Discussion of Maintenance Items 331 and 332

Geoffrey M. Garner
Huawei (Consultant)

IEEE 802.1 TSN TG
2021.08.09

Maintenance Item #331 - 15

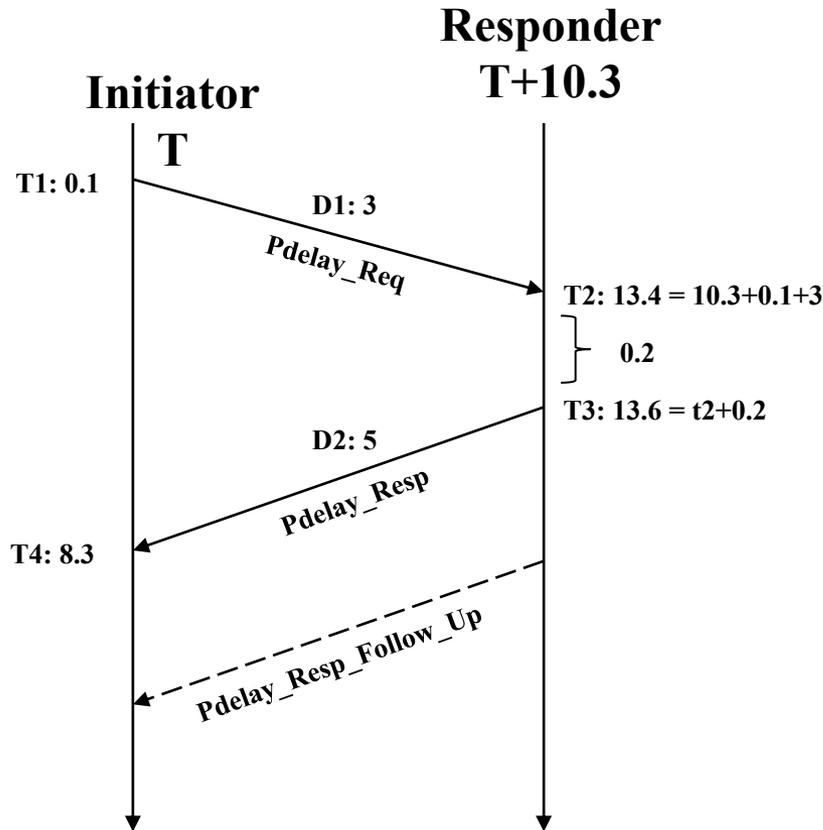
- ❑ The above indicates that the quantity delayAsymmetry must be added to one of the terms when computing meanLinkDelay , to cancel the $-\text{delayAsymmetry}$ contribution that is already included

- ❑ A simple fix is to add an additional term delayAsymmetry to t_3 when computing meanLinkDelay using Eq. (11-5)
- ❑ With this fix, meanLinkDelay for the case of CMLDS is equal to the mean of the link delays in the two directions, expressed in the responder timebase (due to the presence of the $\text{neighborRateRatio } r$ that multiplies the term $t_4 - t_1$ in Eq. (11-5)

- Note that this fix is simpler than the fix given in Maintenance Item #331
 - The writeup in the maintenance item is not correct; the quantity (4) of t_2 in the maintenance item writeup must be subtracted, not added

- However, the fix described here is simpler; it can be obtained from the fix in the maintenance writeup, but corrected by subtracting rather than adding the quantity (4) in t_2 , by adding $\text{neighborRateRatio} * \text{delayAsymmetry}$ to t_2 and to t_3 (doing this cancels the $-\text{neighborRateRatio} * \text{delayAsymmetry}$ of term (4) of t_2 and leaves delayAsymmetry in term (4) of t_3 of the maintenance writeup

Maintenance Item #331 - 17 (Example 1)

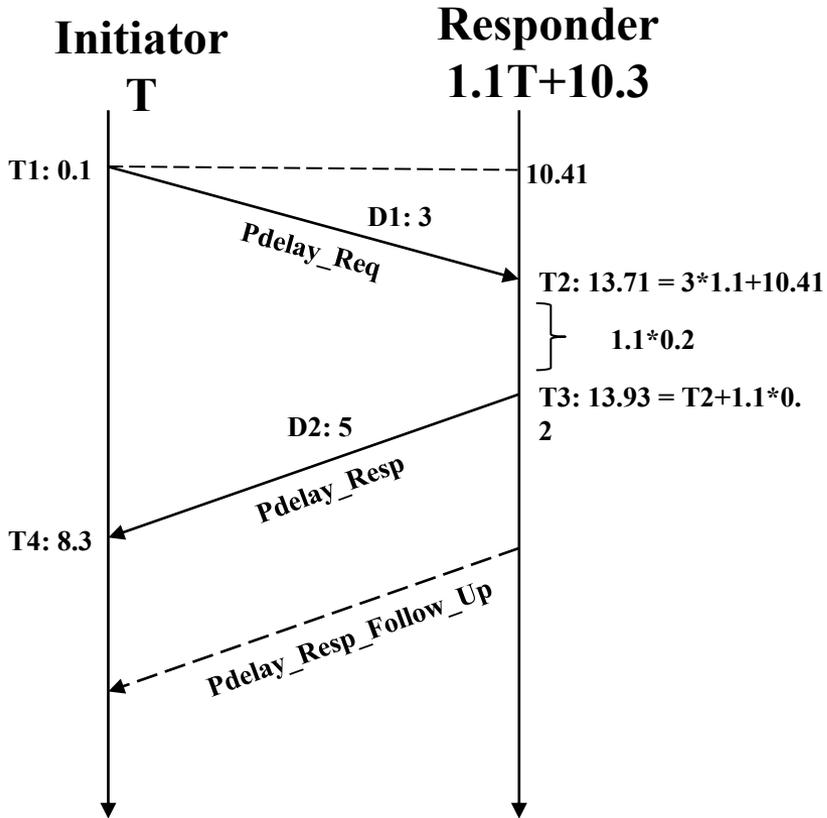
- Common_P2P mechanism (published 802.1AS-2020)
 - ① $\text{Preq_TS} = 0, \text{Preq_CF} = -\text{delayAsy} = -1$ (item b of 11.2.17.2)
 - ② $\text{Presp_TS} = 13, \text{Presp_CF} = -0.4$ (item c of 11.2.17.2)
 - ③ $\text{Presp_Follow_TS} = 13, \text{Presp_Follow_CF} = \text{Preq_CF} + 0.6 = -0.4$ (item d of 11.2.17.2)
 - ④ According to 11.2.19.3.4,
 - I. $t1 = T1 = 0.1$
 - II. $t2 = \text{Presp_TS} - \text{Presp_CF} = 13.4$ (item e of 11.2.17.2)
 - III. $t3 = \text{Presp_Follow_TS} + \text{Presp_Follow_CF} = 12.6$
 - IV. $t4 = T4 = 8.3$
 - ⑤ According to 11.2.19.3.4,

$$\text{MeanLinkDelay} = [(t4-t1) - (t3-t2)]/2 = 4.5$$
Incorrect

$$\text{III. } t3 = \text{Presp_Follow_TS} + \text{Presp_Follow_CF} + \text{delayAsy} \\ = 13 - 0.4 + 1 = 13.6$$

$$\text{MeanLinkDelay} = [(8.3 - 0.1) - (13.6 - 13.4)]/2 = 4$$

Maintenance Item #332 - 2

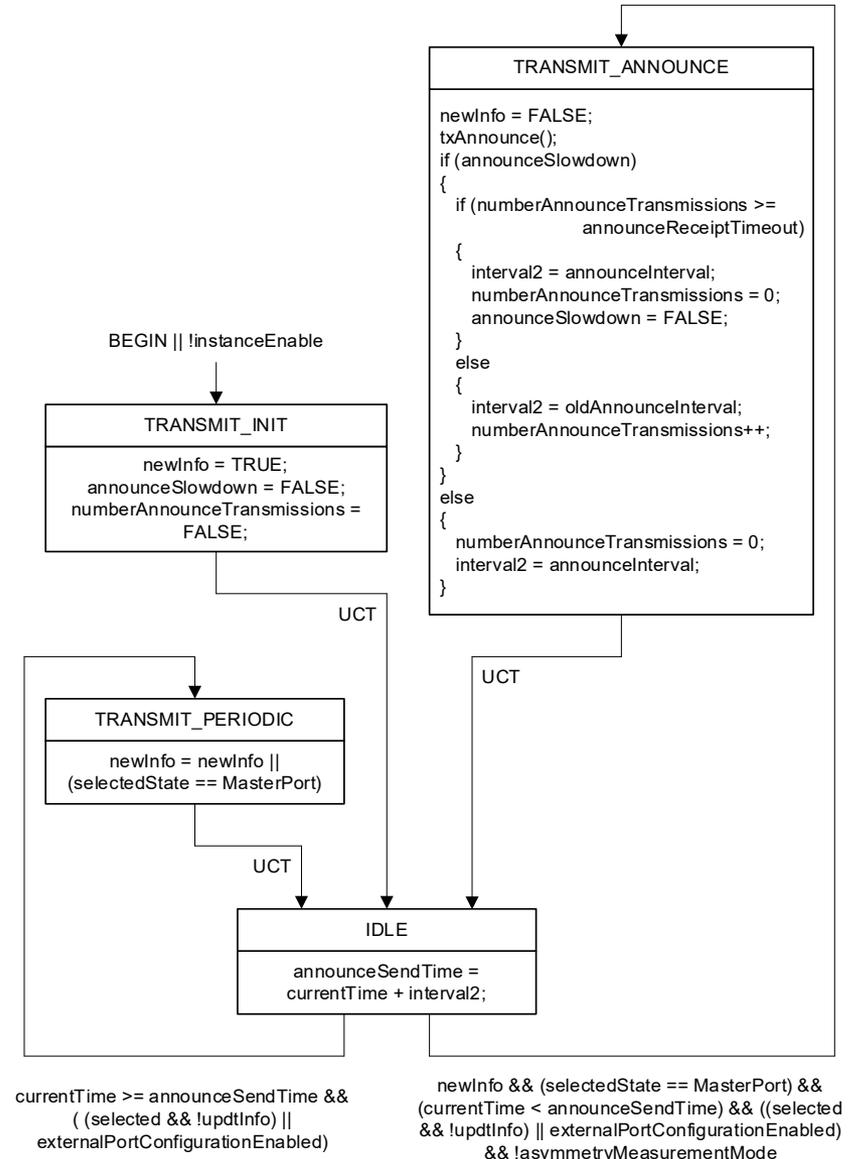
- ❑ An Announce message is transmitted by the PortAnnounceTransmit state machine when the global variable newInfo is set to TRUE
- ❑ From the IDLE state, if newInfo is TRUE and selectedState is MasterPort (and currentTime is not yet announceSendTime), the right branch is taken and an Announce message is sent

Maintenance Item #332 - 3

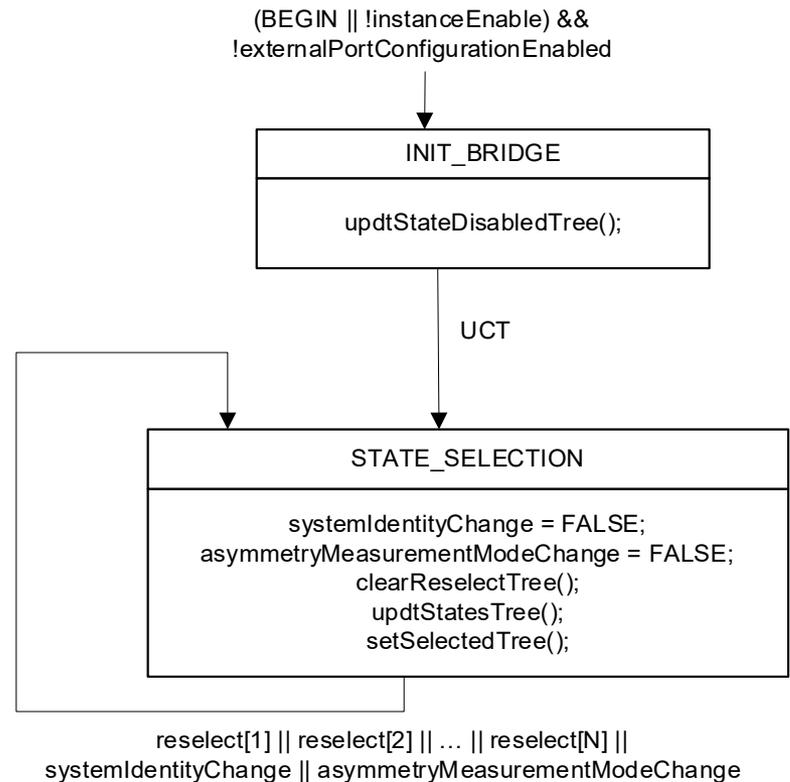
- ❑ In the case of BMCA, `newInfo` is set to `TRUE` as a result of actions by the `PortStateSelection` state machine (via the function `updtStatesTree()`, see 10.3.13.2.4) and the `PortAnnounceInformation` state machine
- ❑ `updtStatesTree()` is invoked when `reselect[j]` becomes `TRUE` for any port `j` (i.e., the triggering of the BMCA)
 - This could occur, e.g., due to receipt of an Announce message (see the `PortAnnounceInformation` state machine in 10.3.12 and on the next slide)

Maintenance Item #332 - 5

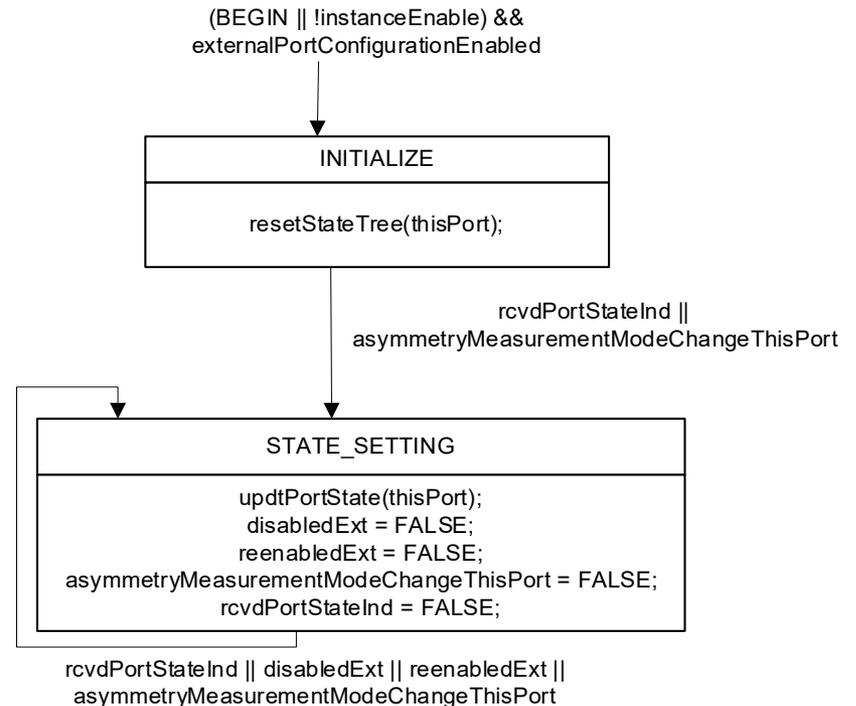
- ❑ In the published 802.1AS-2020, when external port configuration is used newInfo is not set to TRUE, and an Announce message is not immediately sent
- ❑ In external port configuration, the port state is set by the function updtPortState(thisPort) in the PortStateSettingExt state machine

Maintenance Item #332 - 6

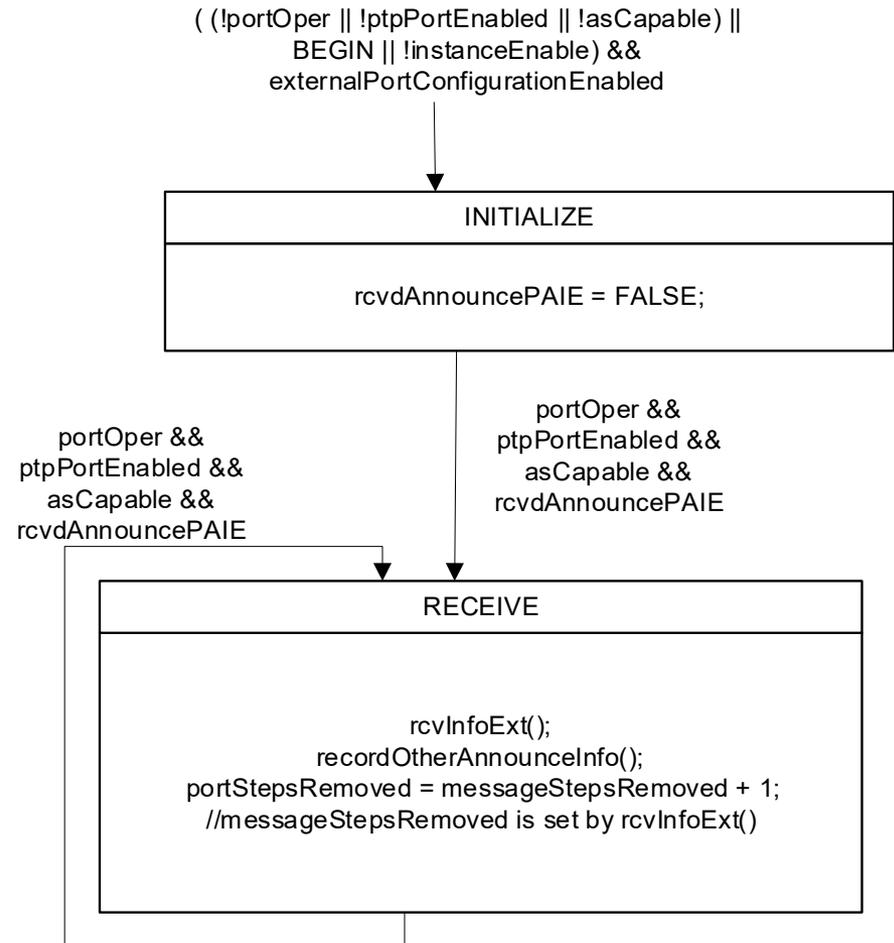
- ❑ In external port configuration, the PortAnnounceInformation state machine is not invoked because the BMCA is not triggered by receipt of an Announce message
 - Instead, the PortAnnounceInformationExt state machine is invoked, which simply records information contained in the Announce message (e.g., time properties information)
- ❑ The problem can be fixed by setting newInfo to TRUE in item c)3) of updtPortState(j), where the port state is set

- ❑ Add the following sentence to item c)3) of the `updtPortState(j)` function (see 10.3.15.2.2): If `portStateInd` is equal to `MasterPort`, set `newInfo` to `TRUE`. Item c)3) then reads:
 - 3) `selectedState[j]` is set to `portStateInd`. If `portStateInd` is equal to `MasterPort`, set `newInfo` to `TRUE`.
- ❑ In Figure 10-12, remove the variable `newInfo` from the arrow going from the `PortAnnounceInformationExt` block to the `PortAnnounceTransmit` block (note that `newInfo` is not set by the `PortAnnounceInformationExt` block)
- ❑ In Figure 10-12, add the variable `newInfo` to the arrow going from the `PortStateSetting` block to the `PortAnnounceTransmit` block
